Memo

To: James Fentress, PE
From: Nicole Smith Associate Planner; 910-341-1611
CC: File;
Date: 4/28/2021
Re: Cape Fear Solar Systems

Engineering has reviewed the plans for the Cape Fear Solar project submitted April 20, 2021 and have the following comments:

Project Name: **CAPE FEAR SOLAR**

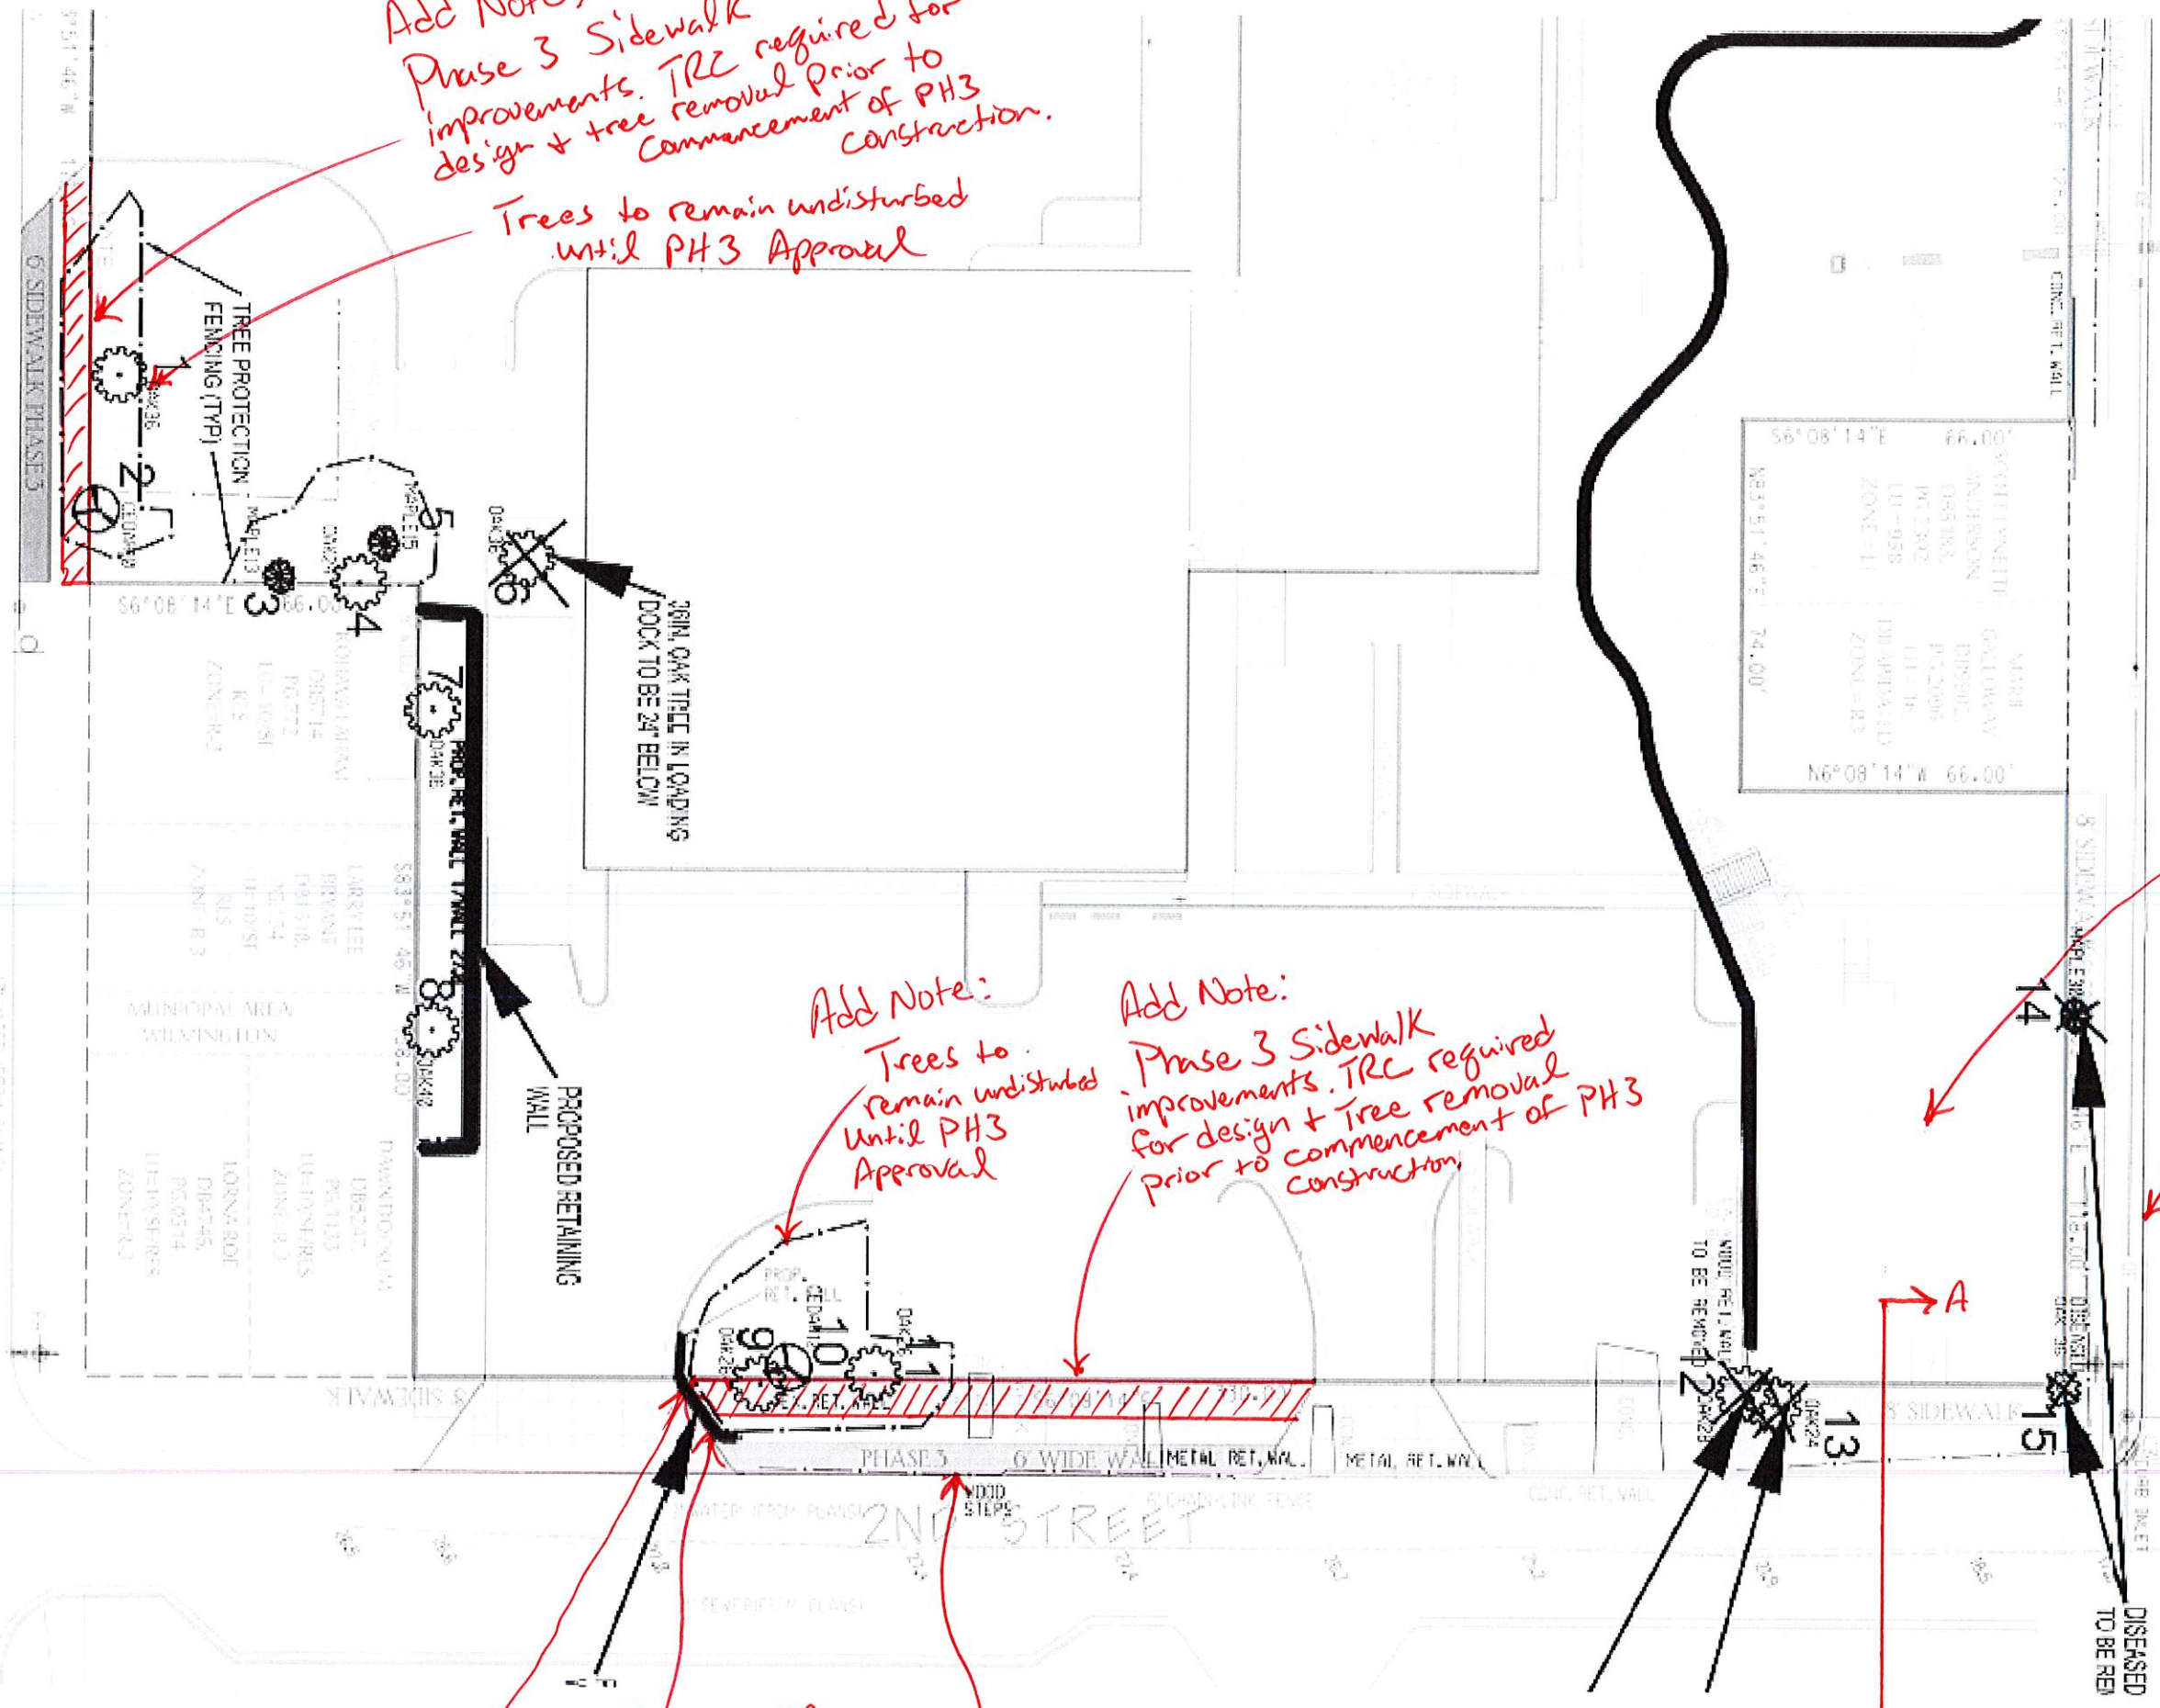
Add Note:
Phase 3 Sidewalk improvements. TRC required for design + tree removal prior to commencement of PH3 construction.

Trees to remain undisturbed until PH3 Approval

Add Note:
Phase II Net Zero House will require a permit modification for future SCM design.

Add Note:
All broken curbing and/or sidewalk panels to be replaced whether proposed or existing

Add Note:
Trees to remain undisturbed until PH3 Approval

Add Note:
Phase 3 Sidewalk improvements. TRC required for design + tree removal prior to commencement of PH3 construction.

Adjust Tree Protection to allow for driveway + grading
Remove Wall

Provide C+G

Provide Cross section with curb + gutter

Departure Sight Triangles (Stop-Controlled)

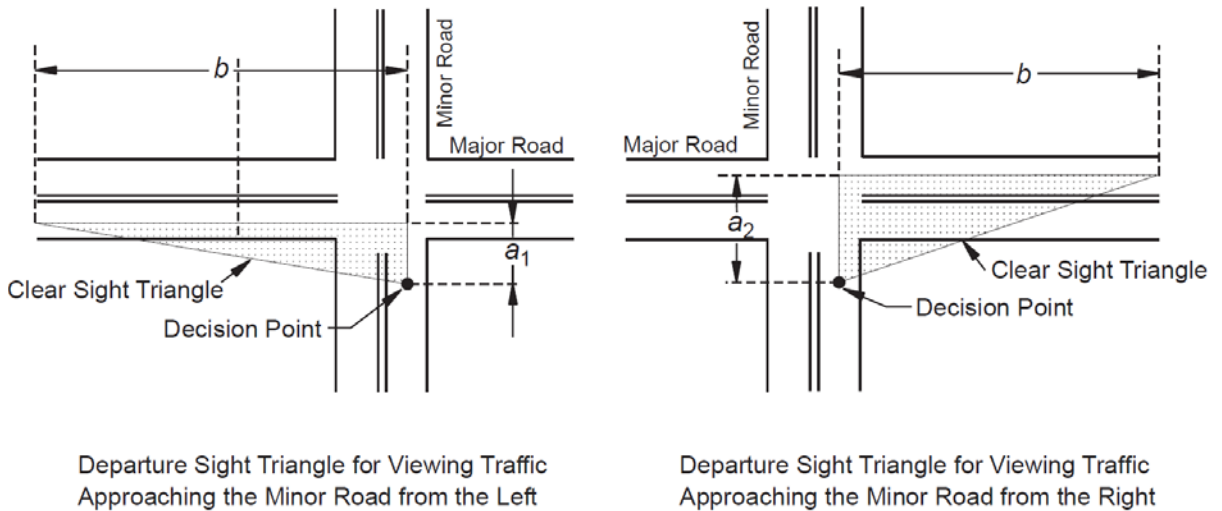
2. **SIGHT DISTANCE TRIANGLE FOR ANY STREET INTERSECTIONS WITH SAID THOROUGHFARES**
This section of S Front St is a major thoroughfare [Chap VII (C) (2) (a) of CofW Tech Stds]. The required triangular sight distance for any street intersections with said thoroughfares shall be provided in compliance with the AASHTO sight distance standards [Sec.18-556 CofW LDC]. Show AASHTO departure sight distance for the street corners of Wright St and Dawson St. Refer the below image for your reference. AASHTO stopping distance is not required. Revise landscape plans accordingly.
